Re: **LETTER OF TRANSMITTAL  
ROOMS TO GO STORE EXPANSION AND REMODEL  
18722 South Dixie Highway  
Cutler Bay, FL 33157  
POST BID ADDENDUM #5**

## **POST BID ADDENDUM NO. FIVE**

Incorporate the following revised CASCO drawings dated 01/29/2024, with revisions including, but not necessarily limited to, those listed below:

**1 DEMOLITION FRONT ELEVATION (EAST)**  
 D3.0 SCALE: 1/8" = 1'-0"

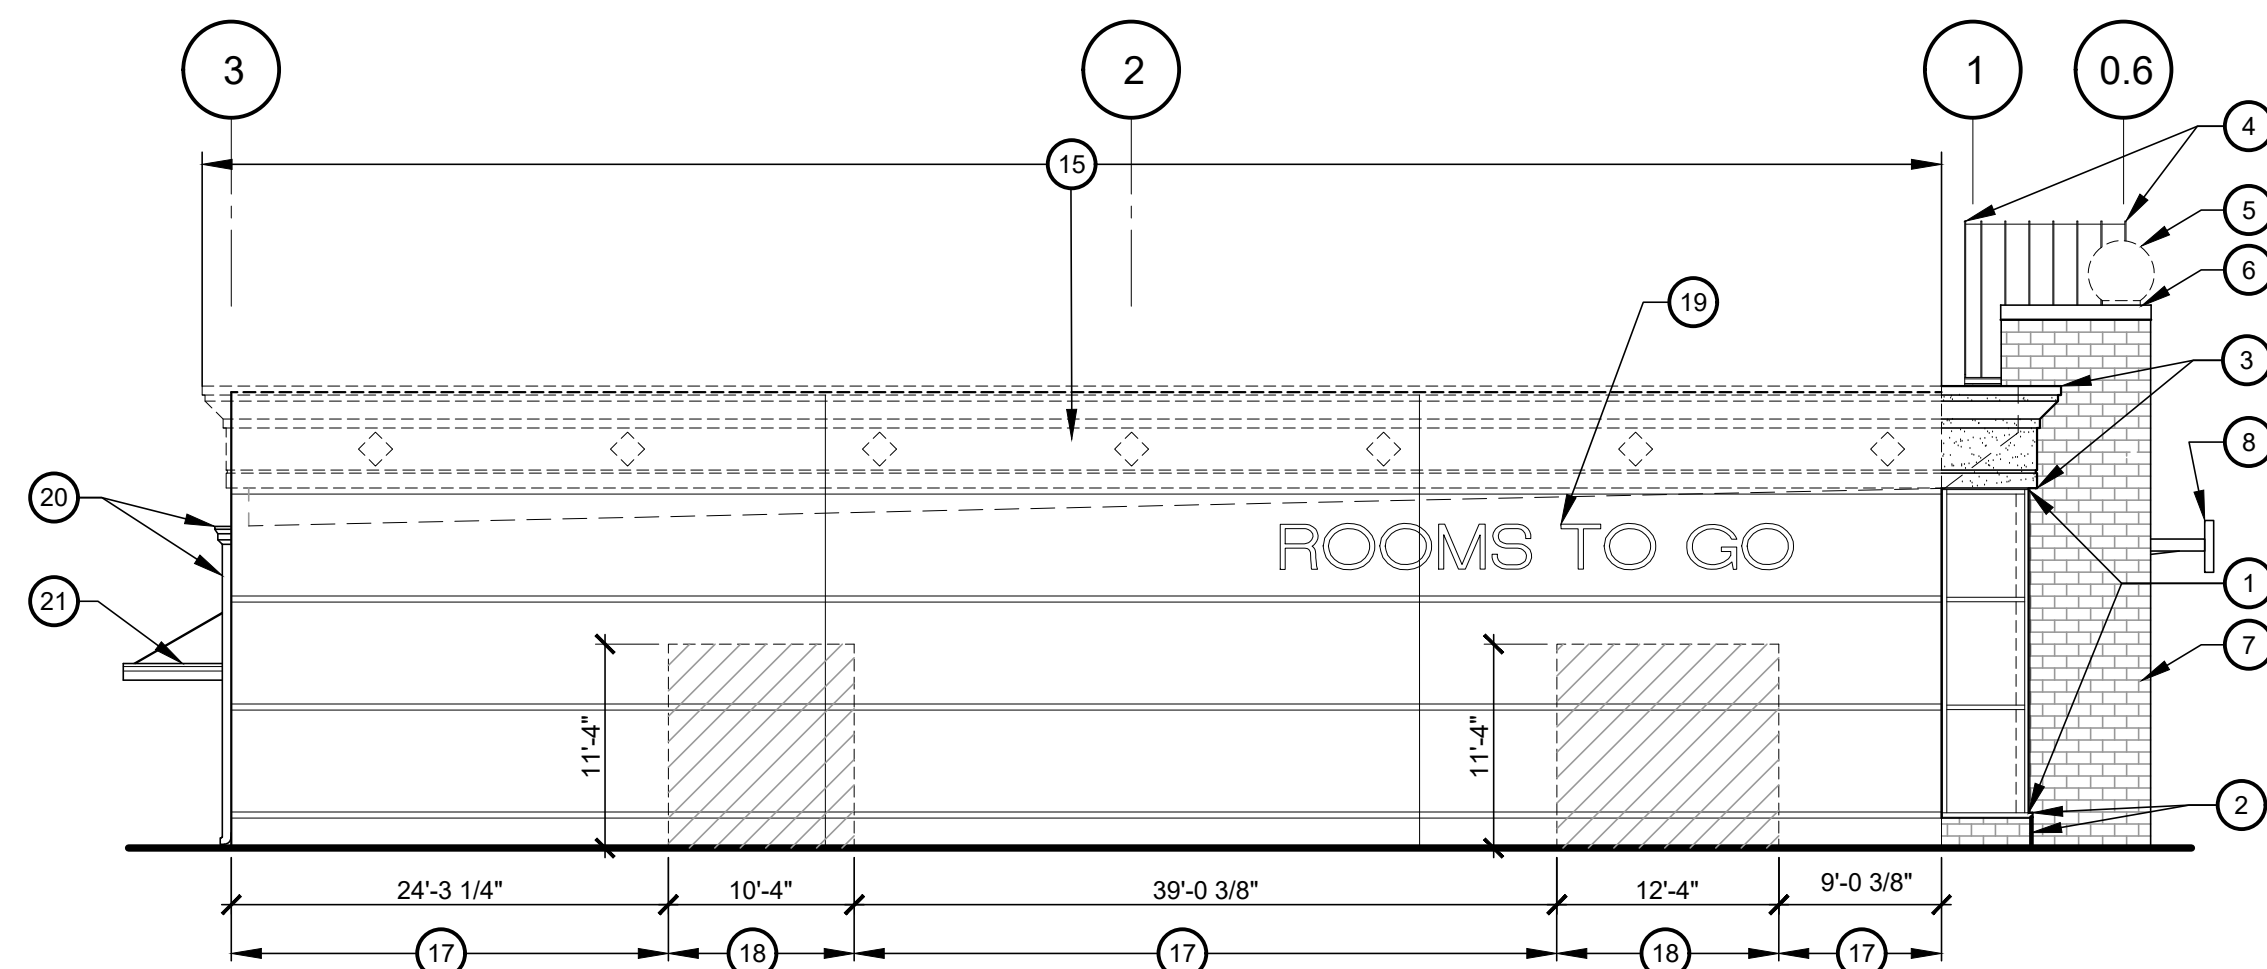
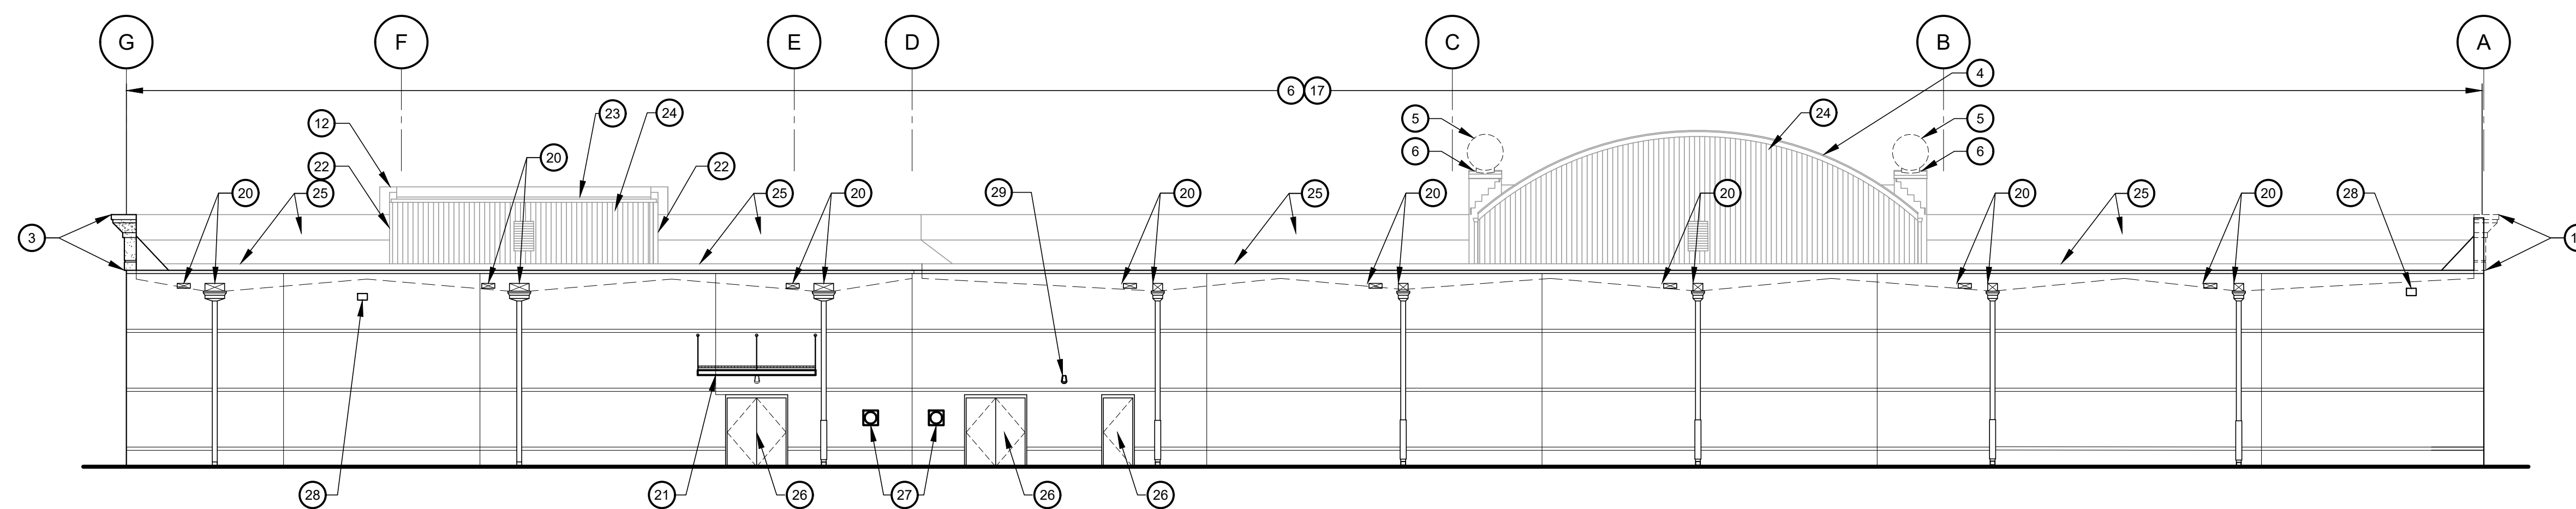
3. Sheet D3.0 – Revision No. 2: Added Note #30.
4. Sheet A0.1 – Revision No. 1: Revised Life Safety Plan. Deleted IDF Room #117.
5. Sheet A1.0 – Revision No. 3: Revised door swing for door #19. Deleted door #4. Revised Floor Plan per updated Design Drawings Rev. #4. Revised Partition Type. Deleted IDF Room #117.

**FLOOR FINISH PLAN**  
**A1.1**

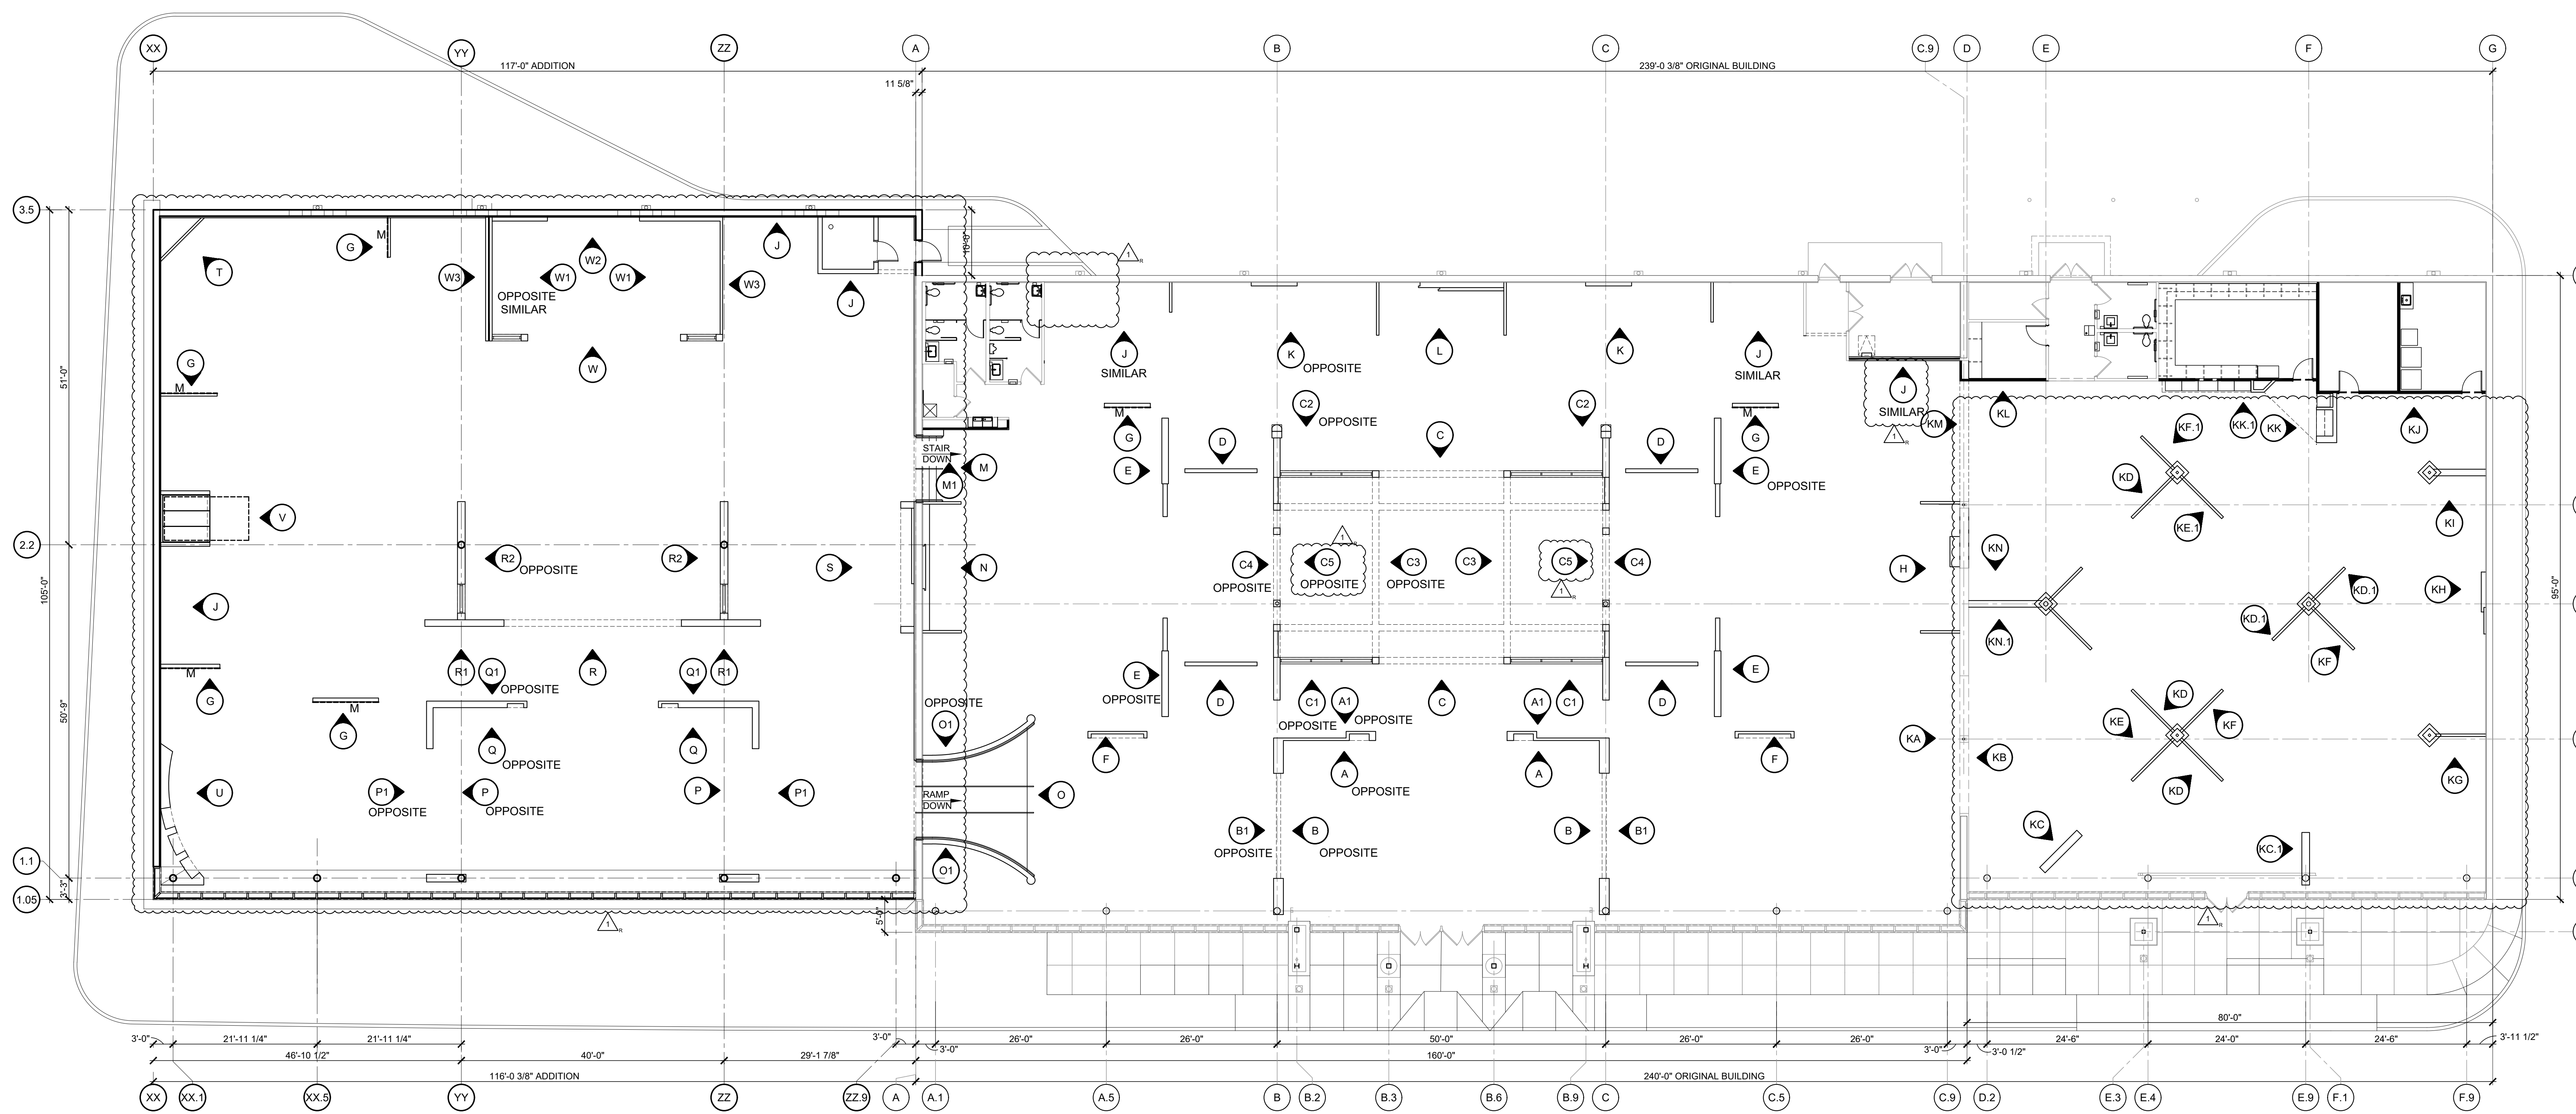
6. Sheet A1.1 – Revision No. 4: Revised Floor Plan per updated Design Drawings Rev. #4. Deleted Ceramic Tile in Adult Sales addition. Revised LVT at entry in Kids Sales. Deleted IDF Room #117.

**1** ROOF PLAN  
**A1.3** SCALE: 3/32" = 1'-0"

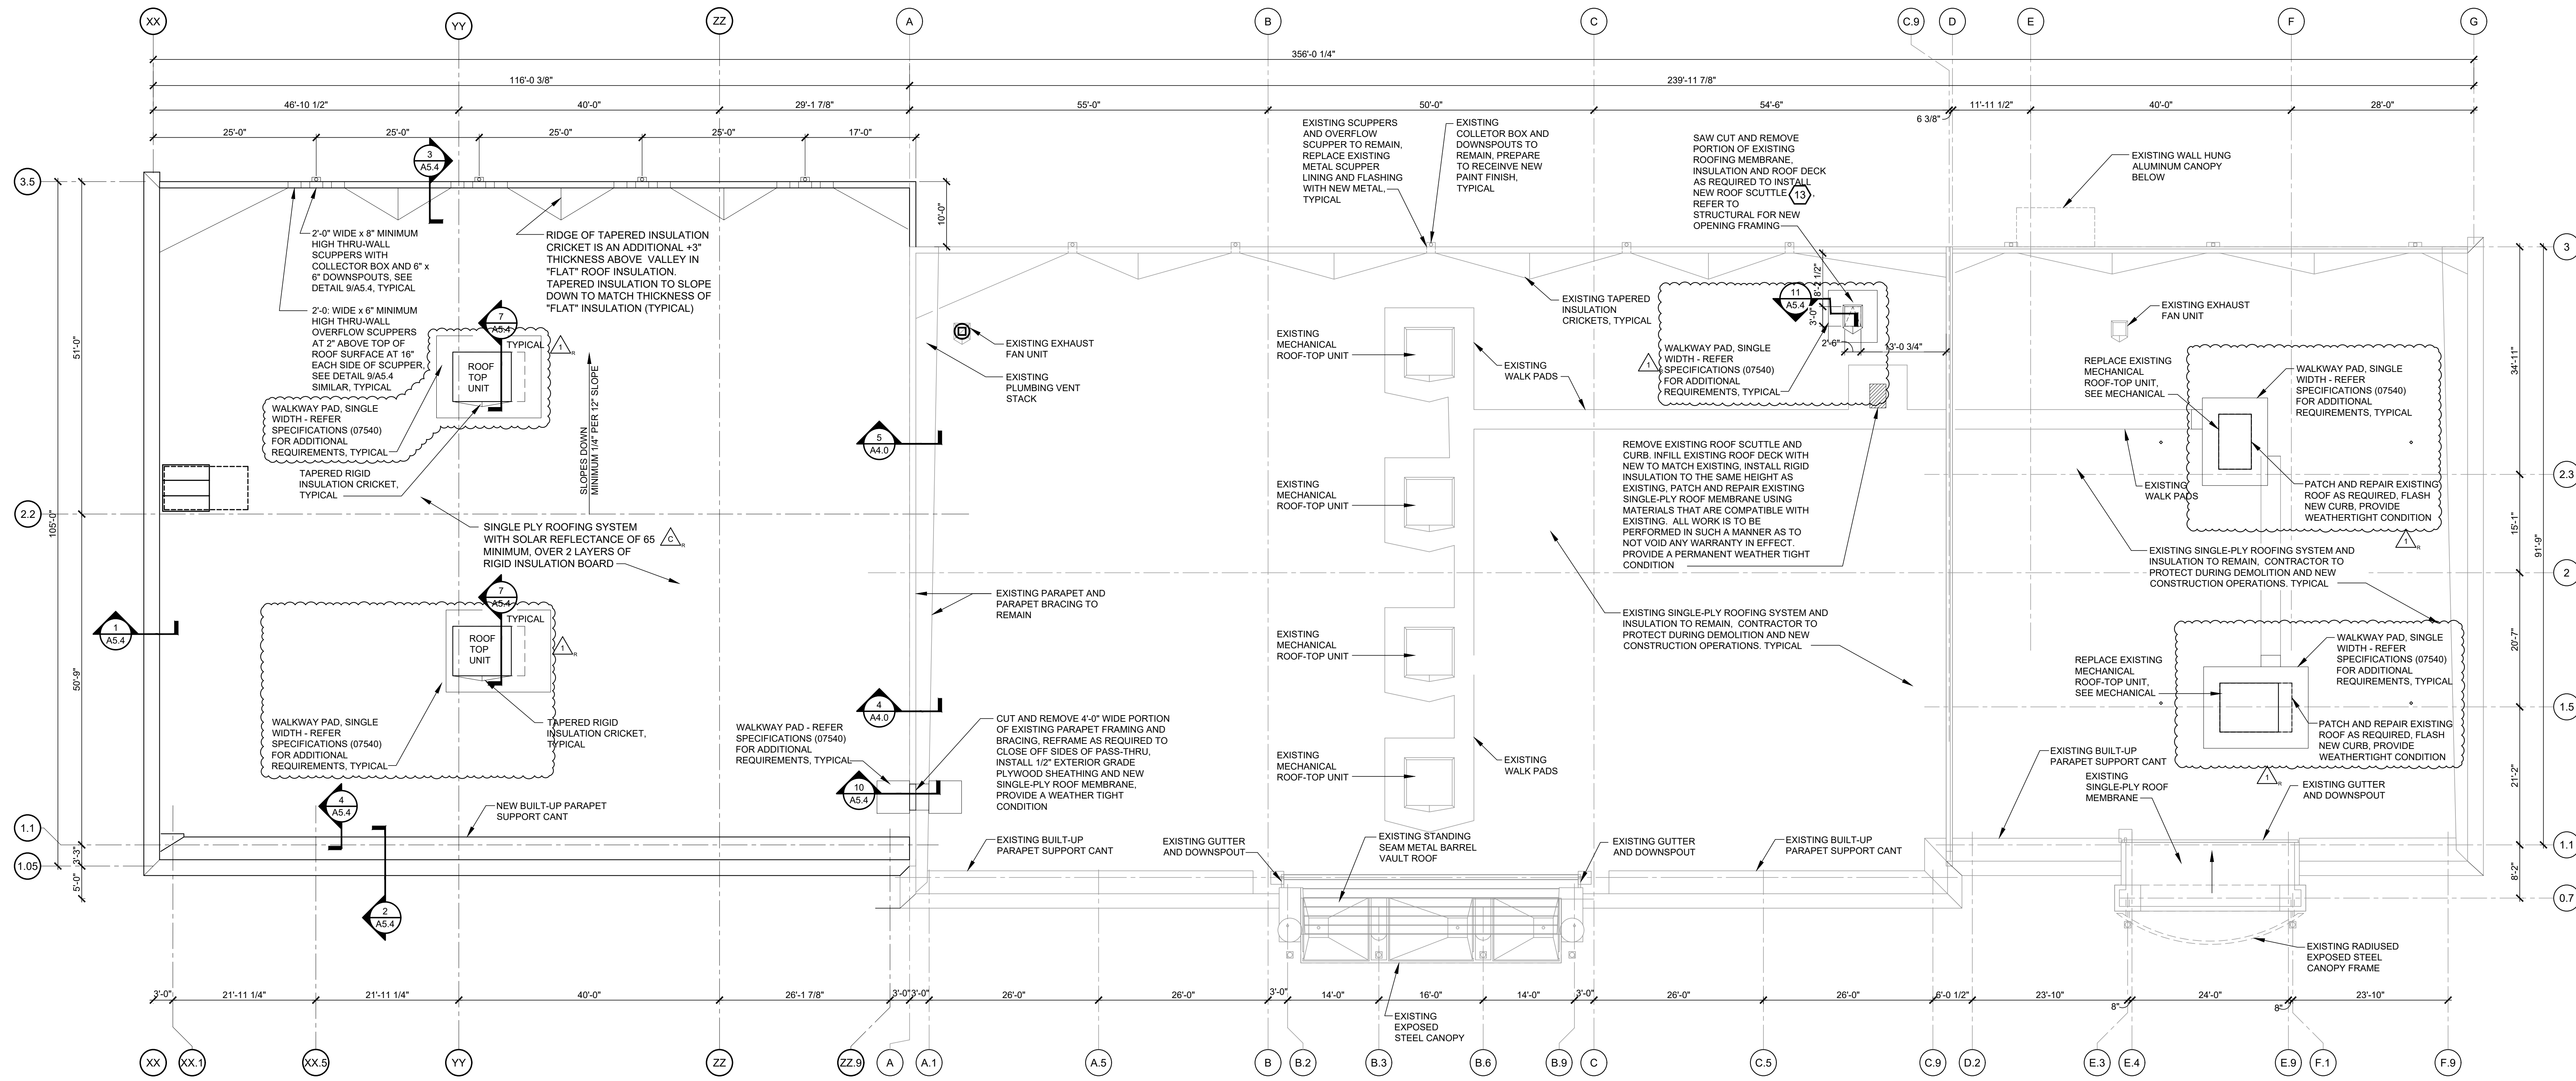
7. Sheet A1.2 – Revision No. 1: Revised Floor Plan per updated Design Drawings Rev. #4. Revised Elevation Bubbles. Deleted IDF Room #117.
8. Sheet A1.3 – Revision No. 1: Deleted Note #1. Revised walk pad note to include “single width”.
